Reply to revision suggestions and comments from Referee #2

Anonymous Referee #2

The manuscript by Hu et al. investigates changes of flood disasters in China using statistical disasters data and also hourly rainfall data at 2420 stations during 1984-2007. The spatiotemporal pattern of rainstorm-related flood disasters was analyzed with respect to trends. They also use GeoDetector method to analyze the driving factors behind flood disasters and the trend during 1984-2007. The work is original and is conducted a systematic way by assessing the trend of the flood disasters in both temporal and special characters. It gets some interesting results but it looks more like a report of flood disaster. The investigation on the driving factors of flood disaster is a bit weak and lacks a more scientific and theoretical method. I have some comments listed below. Further, I highlight some typos and possible inaccuracies. I hope my suggestions can help the authors to further improve the paper.

Temporal variations of frequency of flood hazards during the past 1000 years in Guangdong and Guangxi provinces (the Pearl River basin).

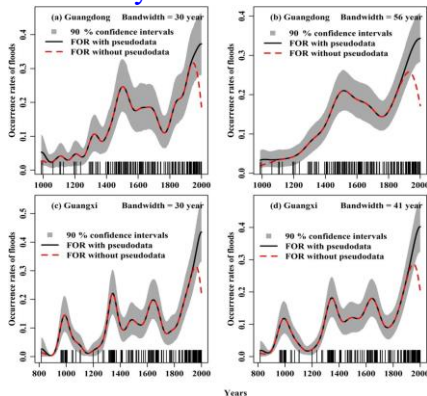
L339-341: Can authors clarify a bit on why there is a larger flood frequency during 1991-2000 than 1984-1990?

Is the dam impact included in the data for the flood frequency analysis? There were certainly more dam regulation after 90th than before in China.

Reply: Thank you for your insightful review, professional suggestion. This result is reasonable and similar was observed in the Pearl River basin. During 1991-2000, there occurred many huge flood such as 1998 flood. Besides, here we referred to flood disasters but not flood processes. Of course, there are close relations between flood events and flood disasters. Here I show you the results we published in HESS for flood disasters in the Pearl River basin, which may further corroborate the results by our current study.

Due to statistical analysis of flood disasters within slightly different areas, the curves for flood disaster changes are a little bit different.
